Clonburris T1

Street Hierarchy, Design & Layout Submission

For Proposed Residential Development
Clonburris T1, Co. Dublin

Compliance Submission in Accordance with
Planning Condition no. 2

Plan of Street 9 / Drawing Ref: CLB-1-00-SW-ZZ-DR-CWO-AR-1000

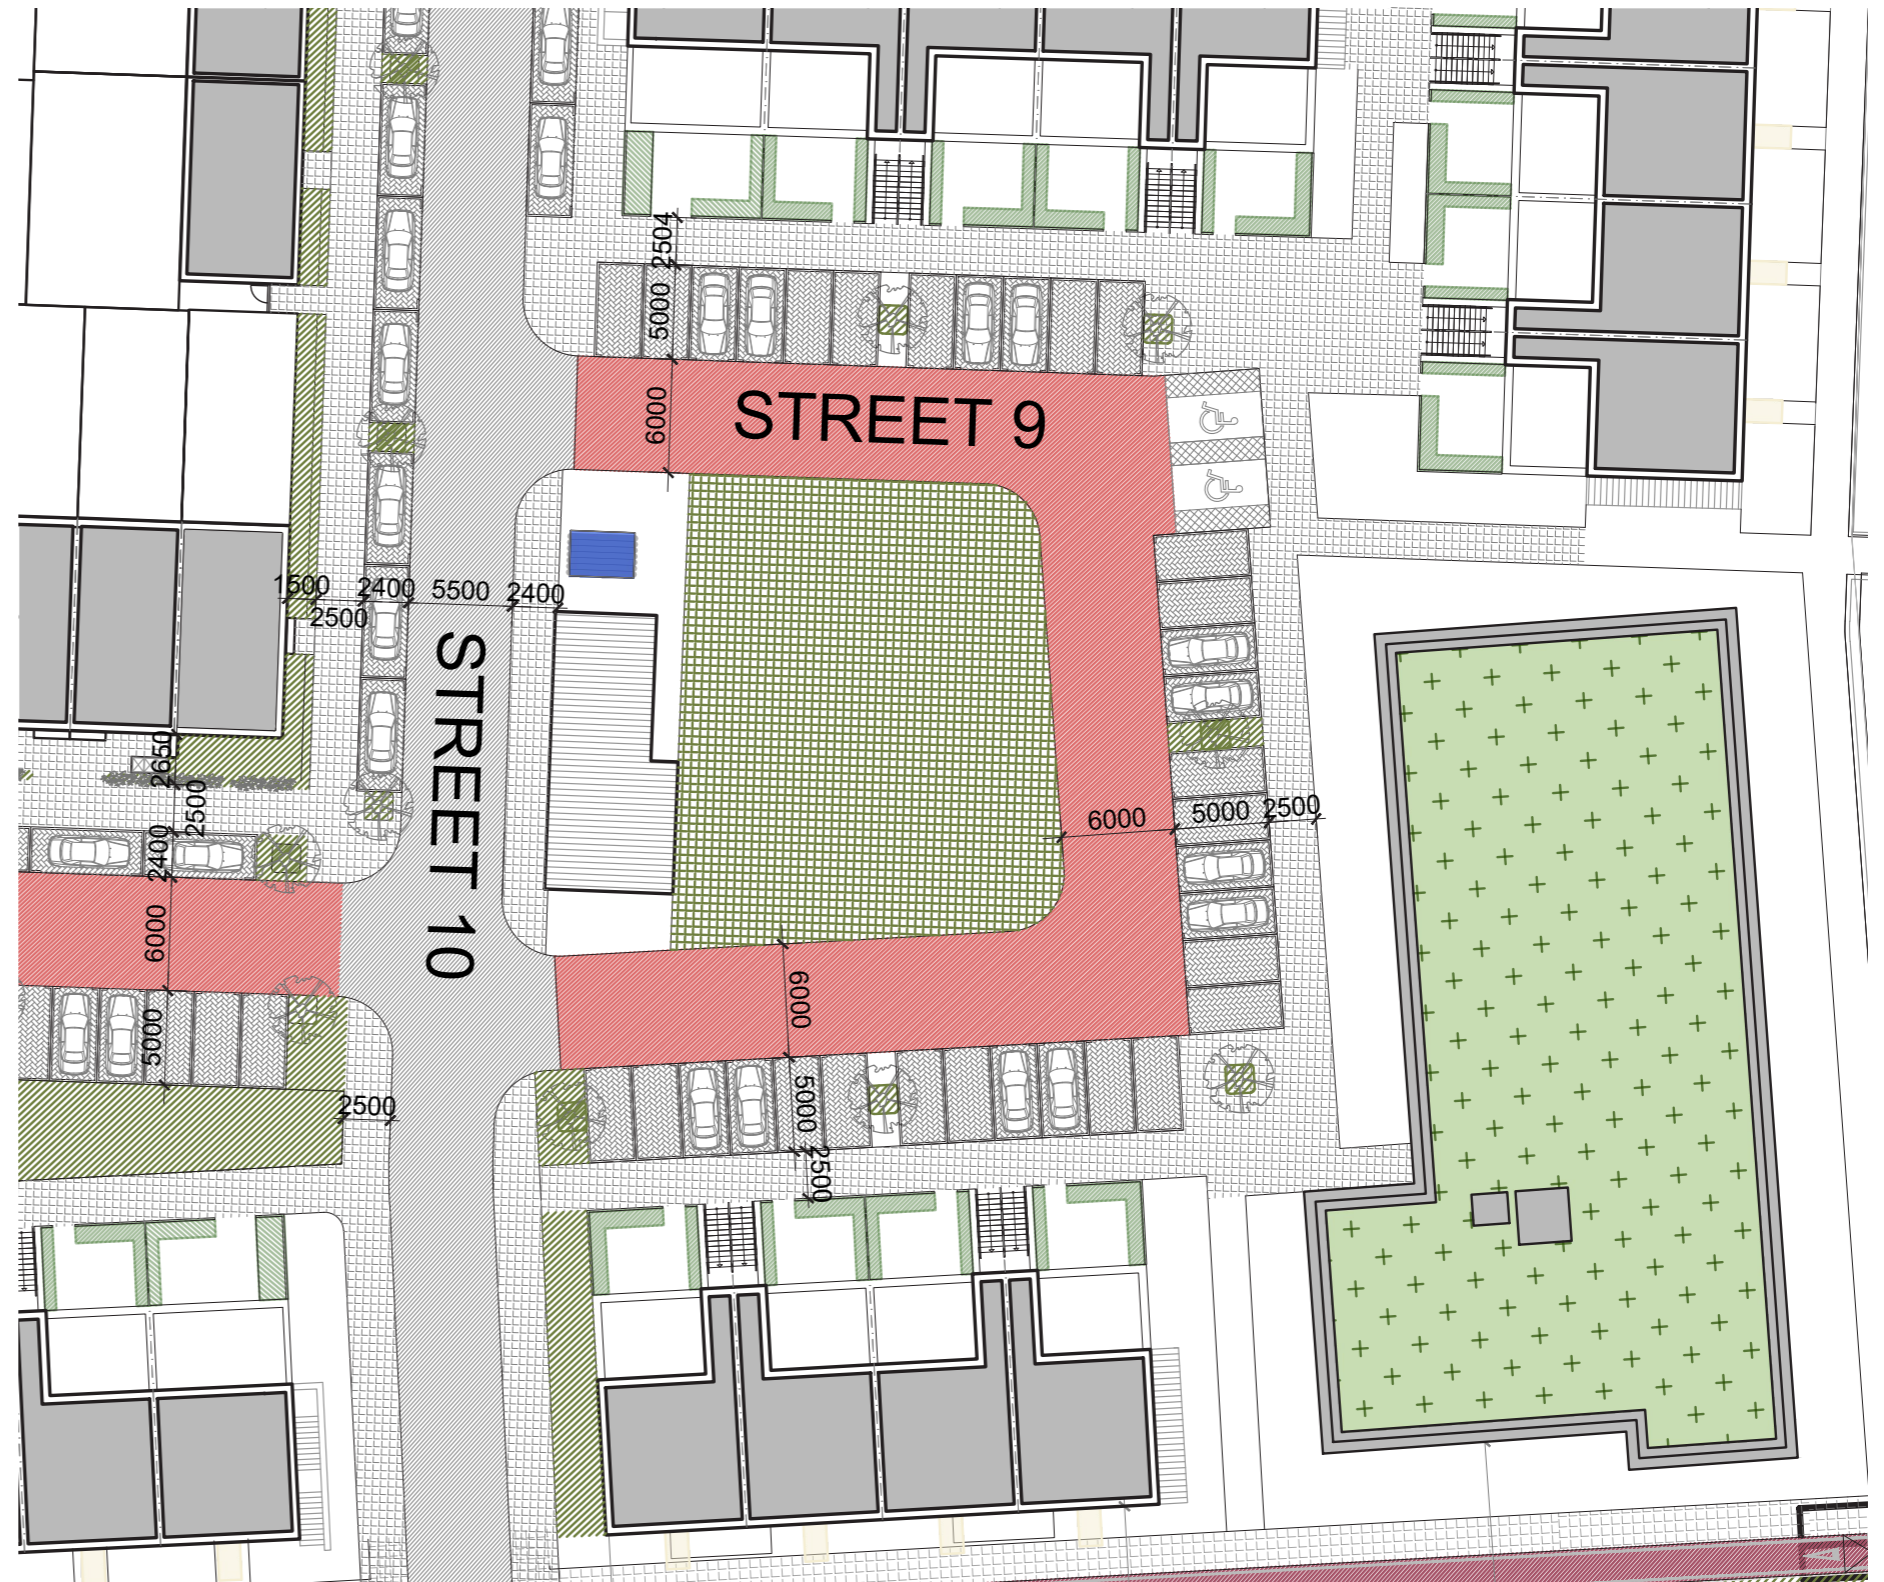
2 (j) Street 9: This street fronts open space. The perpendicular parking shall be retained in this home zone as an exception. The following detail shall be provided:

- The street shall have a carriageway width of 6 meters; 6m shall be provided for reversing for perpendicular parking
- Perpendicular parking bays shall be a minimum of 5m deep
- No parking shall be provided adjacent to the park
- A footpath width of between 2.5 and 4 meters shall be provided;
- Carriageway and footpath shall be shared surface
- Privacy strips/short gardens that range from 1 to 3 metres in depth shall be provided
- Street trees shall be provided in accordance with Condition 7

Street 9 has been designed in accordance with the condition.

- The street has a carriageway width of 6 meters; 6m has been provided for reversing as perpendicular parking is proposed
- Adjacent street has a carriageway width of 5.5 meters.
- Perpendicular parking bays are a minimum of 5m deep.
- No parking has been provided adjacent to the park;
- A footpath width of 2.5 meters has been provided;
- Carriageway and footpath are a shared surface;
- Street trees have been provided in accordance with Condition 7.

Plan of Street 10 / Drawing Ref: CLB-1-00-SW-ZZ-DR-CWO-AR-1000

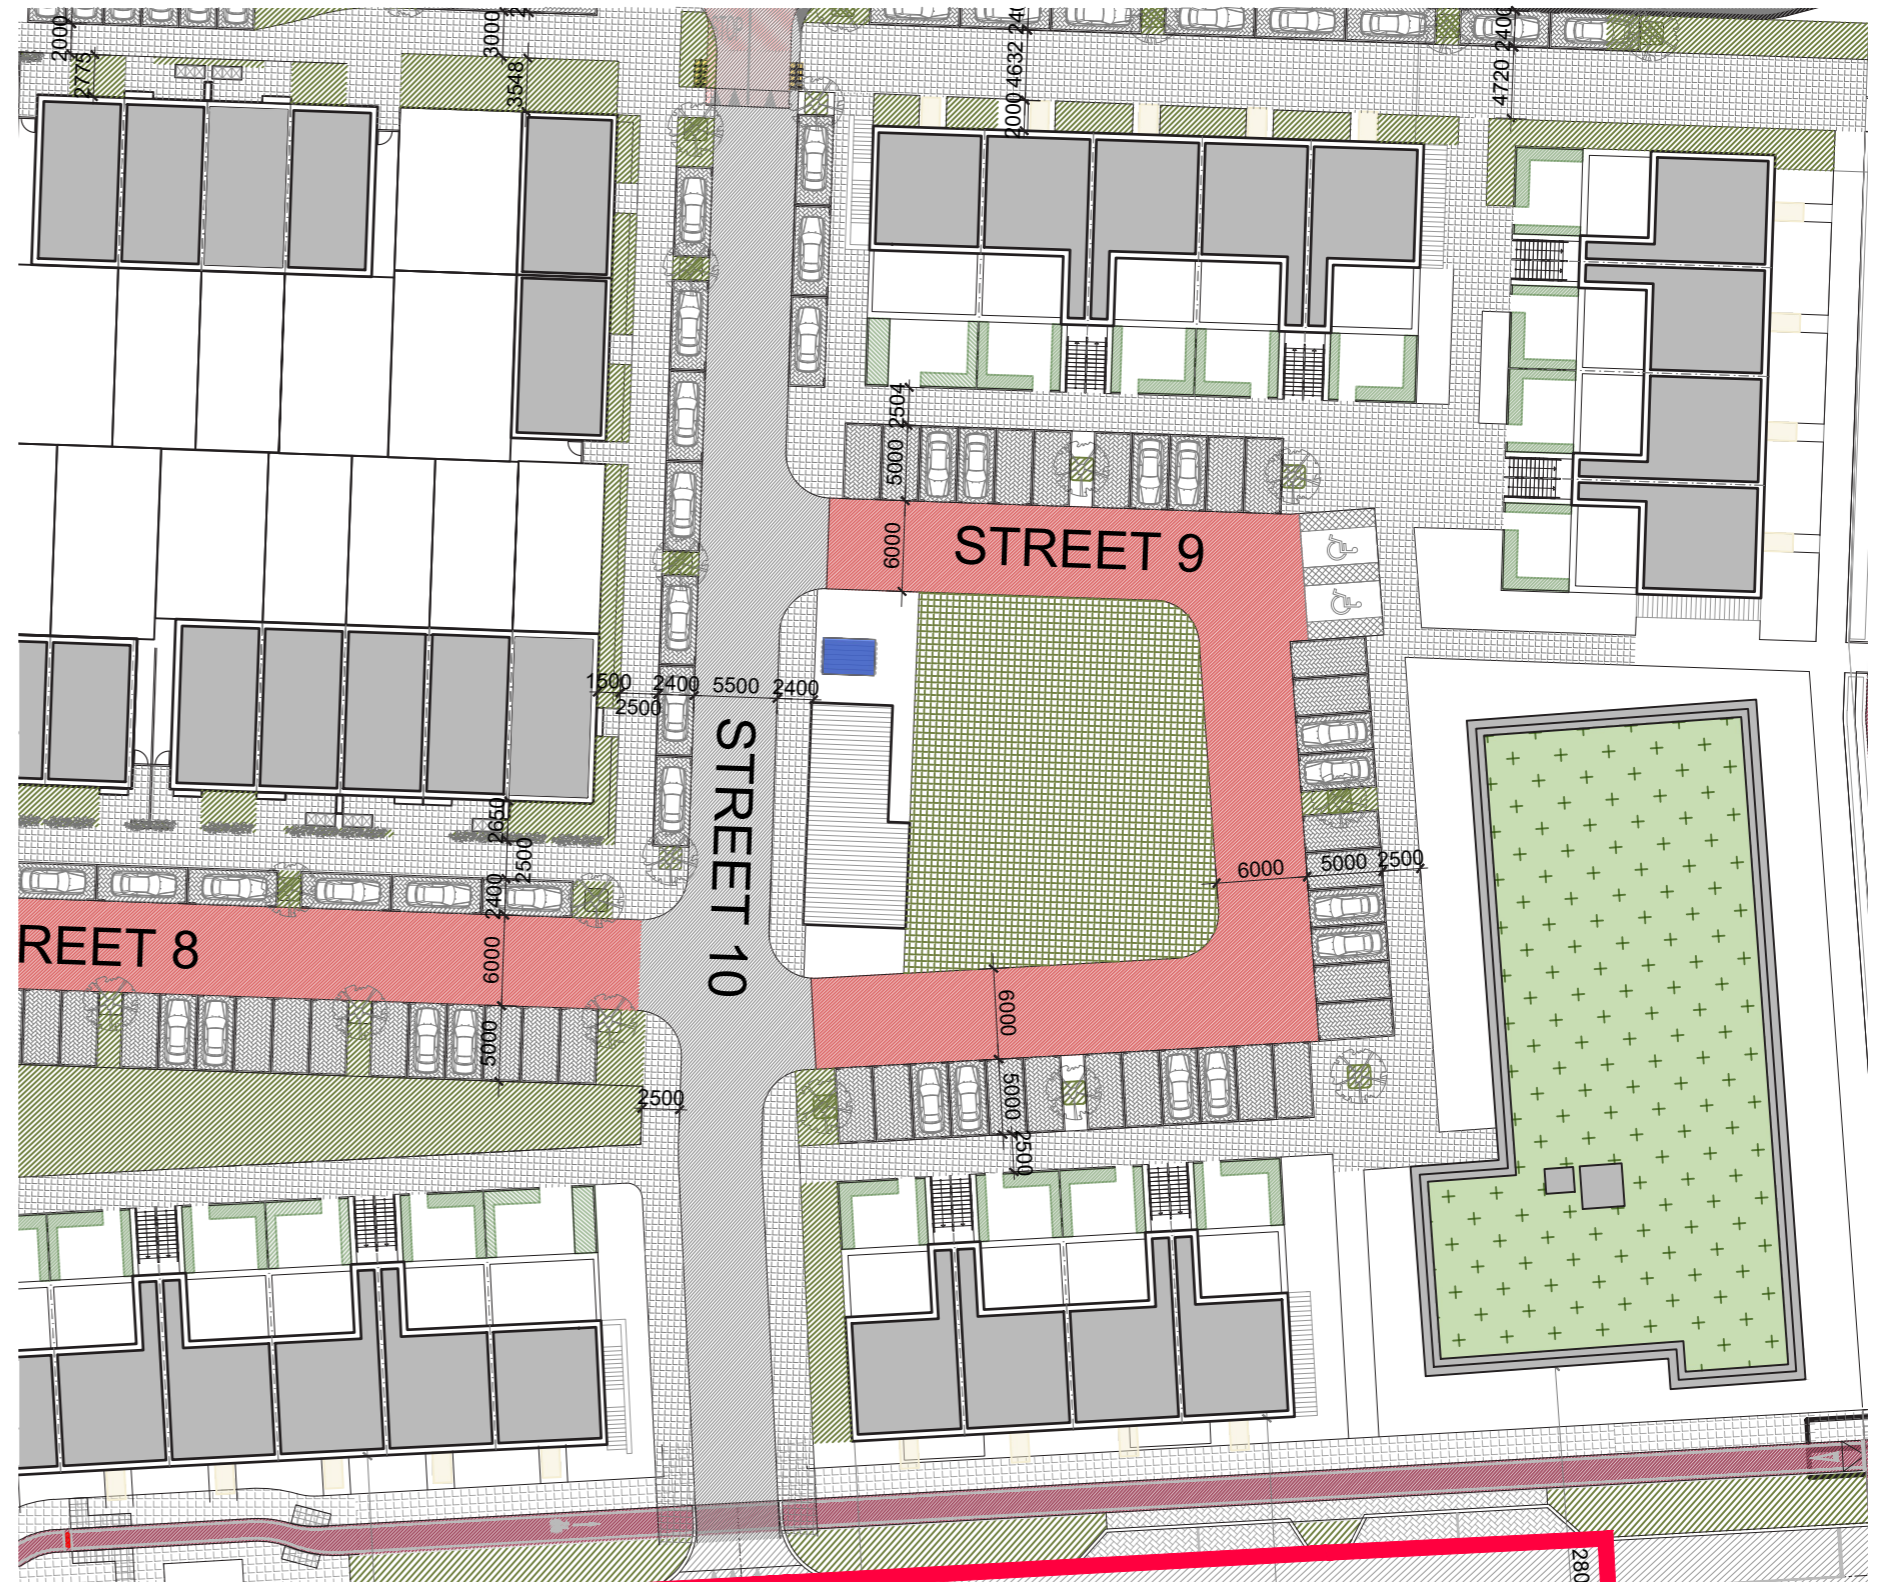
2 (k) Street 10: This street shall be redesigned in general accordance with Figure 2.2.6 Indicative Local Street B. The following detail shall be provided.

- The street shall have a carriageway width of no less than 5 meters and no more than 5.5 meters;
- Only parallel parking shall be provided and it shall be a minimum of 2.4m deep.
- A footpath width of between 2.5 and 4 meters shall be provided;
- Privacy strips/short gardens that range from 1 to 3 metres in depth shall be provided
- No car parking shall be provided adjacent to the communal open space to the east
- Street trees shall be provided in accordance with Condition 7

Street 10 has been designed in accordance with the Figure 2.2.6 'Indicative Local Street B'.

- The street has a carriageway width of 5.5 meters;
- Only parallel parking has been provided and it is 2.4m deep.
- A footpath width of 2.5 meters has been provided;
- Privacy strips of 1.5 meters in depth have been provided;
- No car parking is provided adjacent to the communal open space to the east;
- Street trees have been provided in accordance with Condition 7.

Plan of Street 11 / Drawing Ref: CLB-1-00-SW-ZZ-DR-CWO-AR-1000

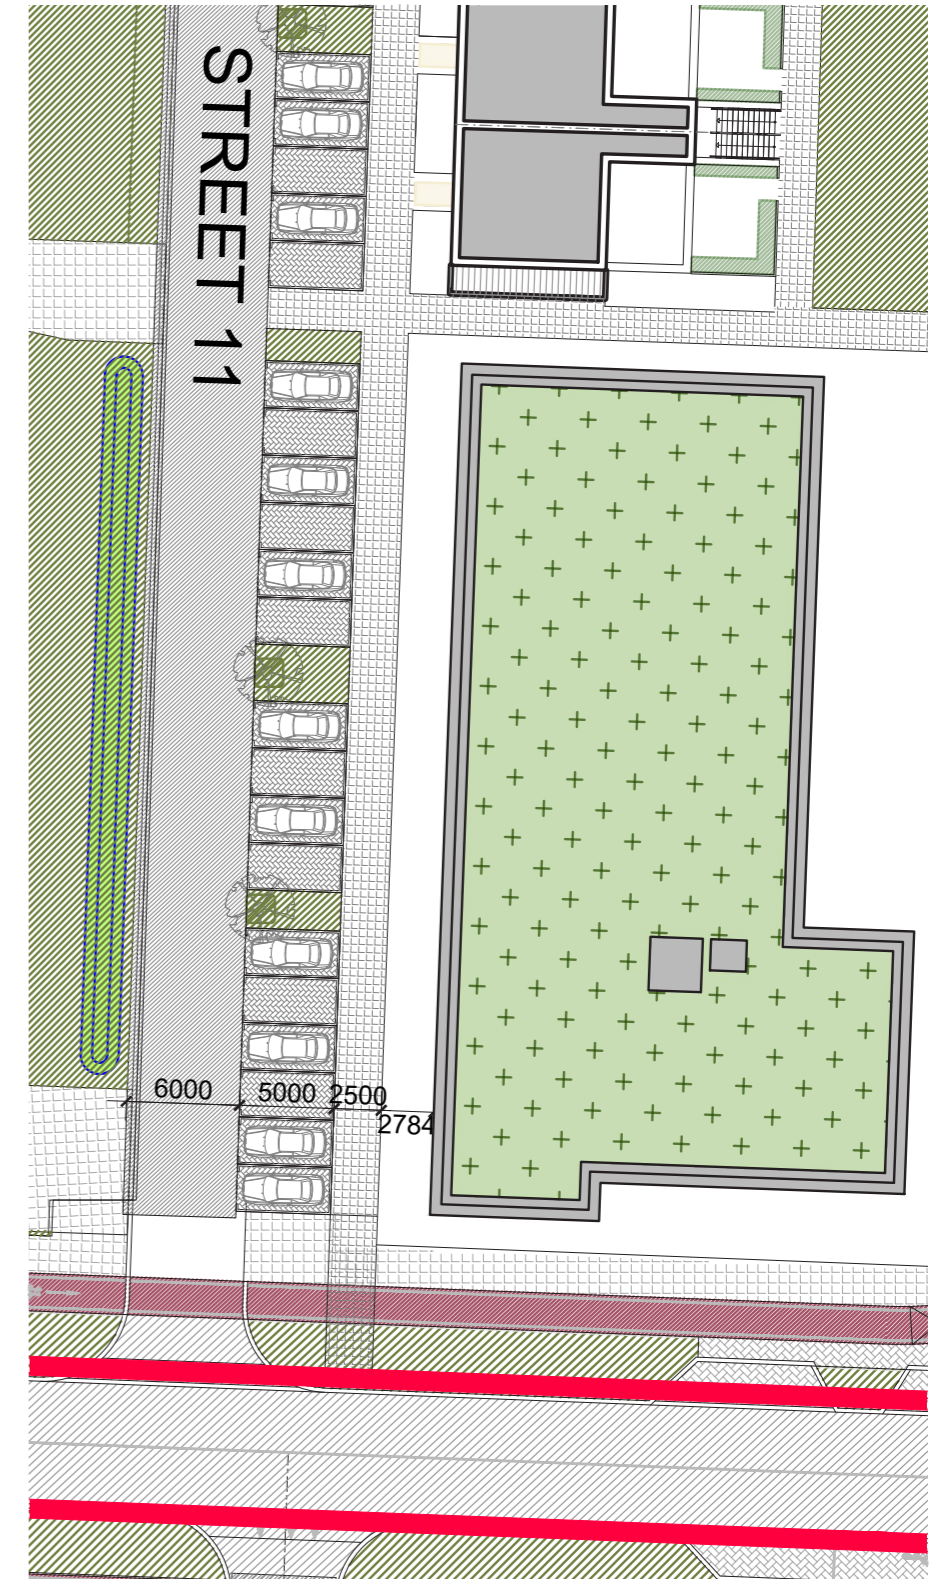
2 (I) Street 11: This shall be redesigned in general accordance with Figure 2.2.6 Indicative Local Street A. The following detail shall be provided:

- The street shall have a carriageway width of no less than 5 meters and no more than 6 meters; 6m shall be provided for reversing if perpendicular parking is proposed
- Perpendicular parking bays shall be a minimum of 5m deep and parallel shall be a minimum of 2.4m.
- At any point along the road, perpendicular parking shall be provided on one side only;
- A footpath width of between 2.5 and 4 meters shall be provided;
- Privacy strips/short gardens that range from 1 to 3 metres in depth shall be provided
- Street trees shall be provided in accordance with Condition 7
- If feasible without negatively impacting on the open space to the west, parallel car parking may be provided adjacent to the park.

Street 11 has been designed in accordance with Figure 2.2.6 'Indicative Local Street A'.

- The street has a carriageway width of 6 meters; 6m has been provided for reversing as perpendicular parking is proposed
- Perpendicular parking bays are a minimum of 5m deep.
- Perpendicular parking is provided on one side of the road only;
- A footpath width of 2.5 meters has been provided;
- Privacy strips of 2 to 2.7 meters have been provided;
- Street trees have been provided in accordance with Condition 7.
